# Access Compliance Report

## Public Rights-of-Way

### (Curb Ramps)

Intersection ID: 14258	Main Street: BERKELEY_AV	Cross Street: LAFAYETTE_AV	Location: NE
ADA ID: D53028DEF91F	Ramp Type: Directional1	Initial Pass/Fail: Fail	Overall Compliance: No
			Severity Score: 16.25

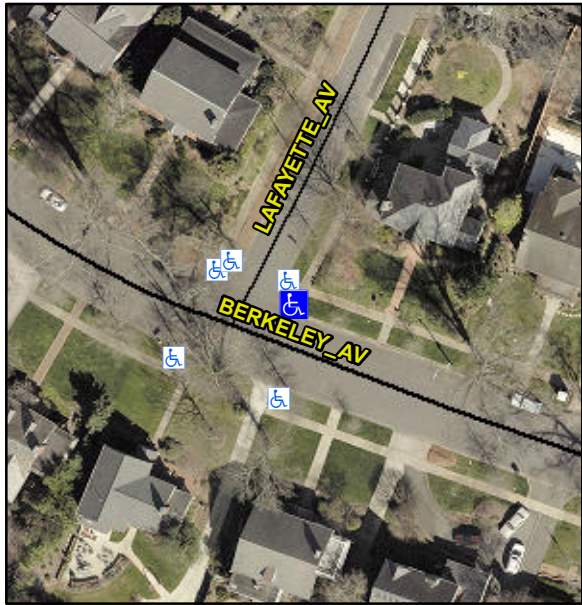
Codes/Mitigation Info/Possible Solution			Field Measurements/Component Compliance							
	Possible Solutions:		<b>Compliance</b>			<b>Description</b>			<b>Data</b>	
	<b>Remove &amp; Replace Entire Ramp.</b>		N/A	Ramp Length (in)	74.0	N/A	Grade Break?	N/A		
			Yes	Ramp Width (in)	63.0	N/A	Grade Break Slope (%)	0.0		
			Yes	Ramp Slope (%)	7.1	N/A	Grade Break XSlope (%)	0.0		
			No	Ramp XSlope (%)	3.7					
			N/A	Flare Type LT	N/A	N/A	Flare Type RT	N/A		
			N/A	Flare Slope LT (%)	N/A	N/A	Flare Slope RT (%)	0.0		
			N/A	Flare Traversable LT?	N/A	N/A	Flare Traversable RT?	N/A		
			N/A	Landing Length (in)	0.0	N/A	DWS Provided?	N/A		
			N/A	Landing Width (in)	0.0	N/A	DWS Contrast?	N/A		
		N/A	Landing Slope (%)	0.0	N/A	DWS Length (in)	N/A			
		N/A	Landing X Slope (%)	0.0	N/A	DWS Full Width?	N/A			
		N/A	Landing Curb? (Y/N)	N/A	N/A	DWS Offset LT (in)	N/A			
		N/A	Shared Landing?	N/A	N/A	DWS Offset RT (in)	N/A

N/A	Gutter Ponding?	0.0	N/A	Gutter Slope (%)	N/A			
		N/A	Gutter Lip Ht (in)	0.0	N/A	Gutter X Slope (%)	N/A			
		N/A	Painted X Walk1?	No		Road Slope (%)	4.0			
			X Walk 1 Direction	To S		Road X Slope (%)	1.3			
			X Walk 1 Width (in)	N/A		Clear Space?	N/A			
			X Walk 1 Slope (%)	4.0	N/A	Clear Space to XWalk (in)	N/A			
			X Walk 1 X Slope (%)	1.3	N/A	Storm Grate/Utility Hazard?	N/A			
		N/A	Ramp inside XWalk1?	N/A		Storm Grate/Utility Type				
		N/A	Any Obstructions?	N/A						
			Obstruction Type		No	Surface Condition? (G/P)	Poor			
					N/A	Curb Slope (%)	9.3			
		Total Cost:	\$	1600.00						
		Surveyor Notes:								
		<b>DAMAGED CURB/RAMP</b>								
		PROW/ADA:								
		<b>R304.5.3, R302.7</b>
